AEBS-12 – Industry Input

Car to Bicycle – Why Car2Bicycle AEBS is such a challenge

AEB IWG 12 – Industry Input

EURO NCAP Test results (according to AEBS-10-04))

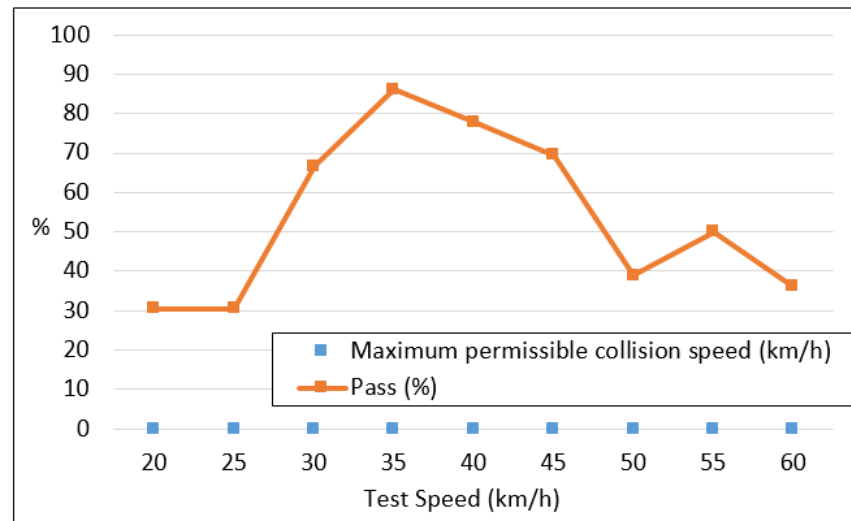
Collision avoidance in the speed range of 20-60km/h does not reflect the performance of today's AEB systems.

Number of vehicles	Pass at 20 km/h	Pass at 42 km/h	Pass at 60 km/h	Pass at all test speeds	Fail at all test speeds
36	31 %	69 – 78 %	36 %	6 %	8 %

Chart 1: Average Platform Longevity by Decade of Introduction and Vehicle Type

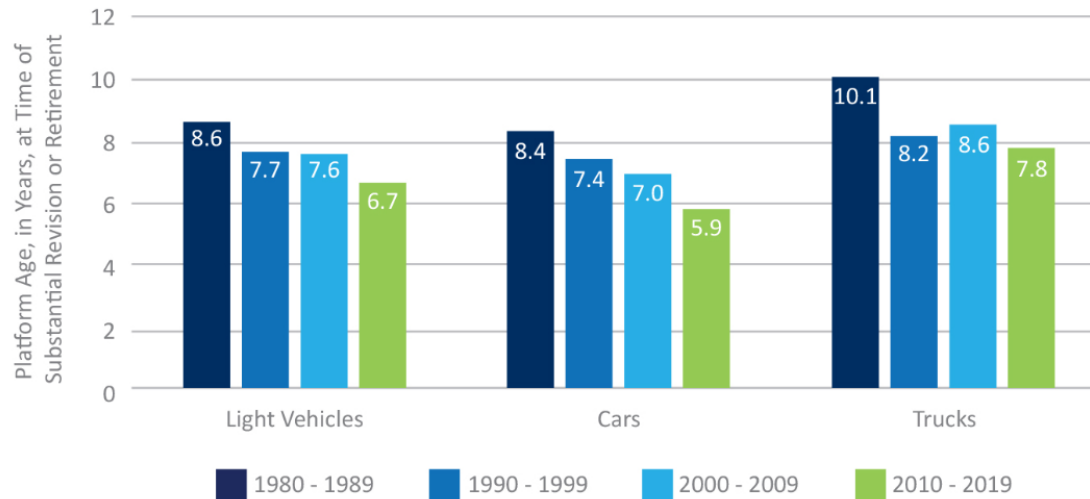
- ▶ If the average platform longevity is assumed to be 6.7 years, additionally a development time of 3-5 years has to be taken into account. Especially for small-scale series the platform longevity can be significantly longer.
- ▶ Even assuming average development and production periods the AT date for C2B in 07/2026 will affect vehicles whose development started around 2015.
